Technical Update (July 2003)

Spring Snack vend flap modification

Washer to be added here

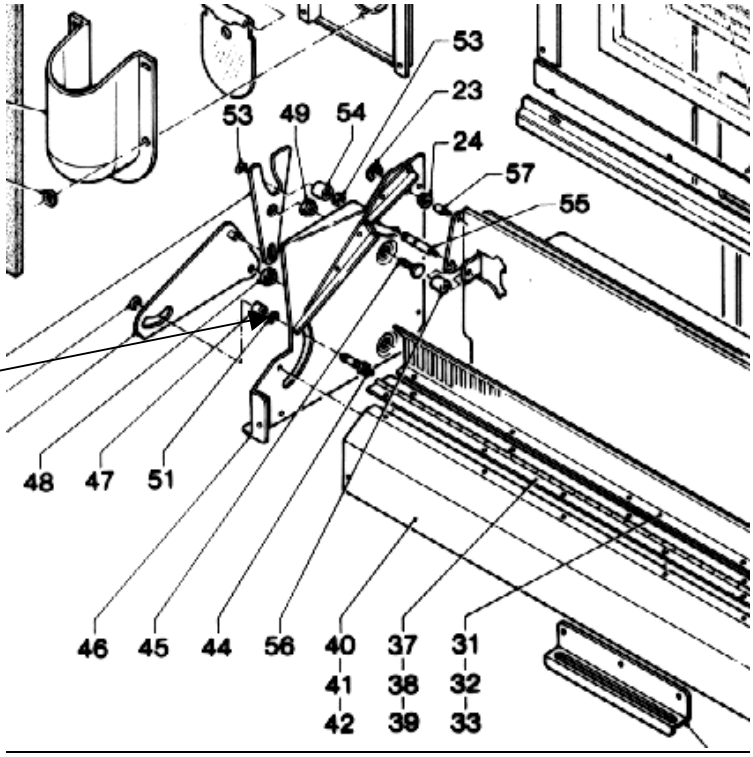
1. The mechanism for the vend flap, overrides on its mounting bracket and restricts its movement

2. The problem happens occasionally and prevents the vend flap from being opened

There is nothing to stop the mechanism from overriding onto its mounting

Add a washer to the mechanism assembly, which prevents the override occurring

We can supply a washer of the correct dimensions, the part number is .
